**THE STATE OF FLORIDA
DEPARTMENT OF ENVIRONMENTAL PROTECTION**

DEP File No. SC51-277316
Pasco County

INTENT TO ISSUE

The applicant, Pasco County Board of County Commissioners, applied on September 11, 1995 to the Department of Environmental Protection for a permit to construct a leachate storage tank and treatment facility adjacent to the existing Resource Recovery Facility, located near Hays Road, 2 miles north of S.R. 52, Springhill, Pasco County, Florida.

PROJECT
DETAIL
DEC 08 '95
CAMP DRESSER & MINERALS

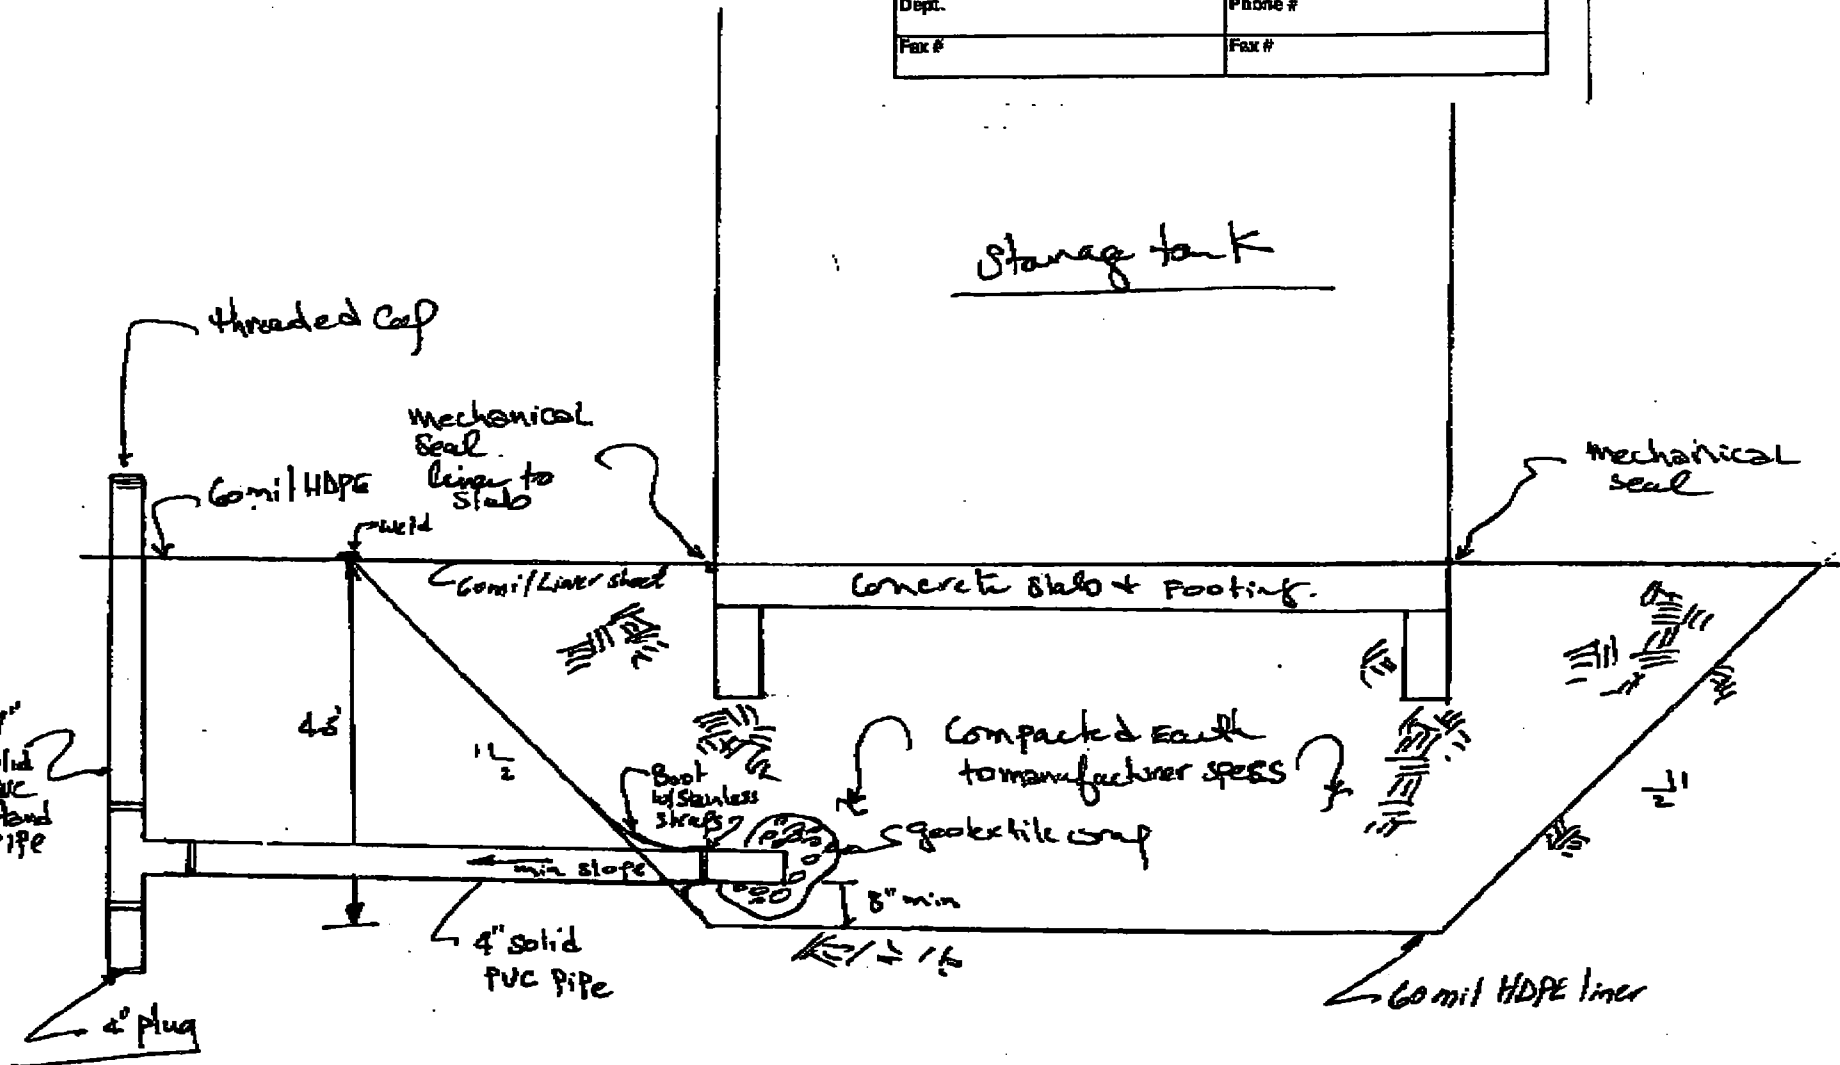
Kim - We can provide say 4 leak detection ports spaced evenly around the tank diameter
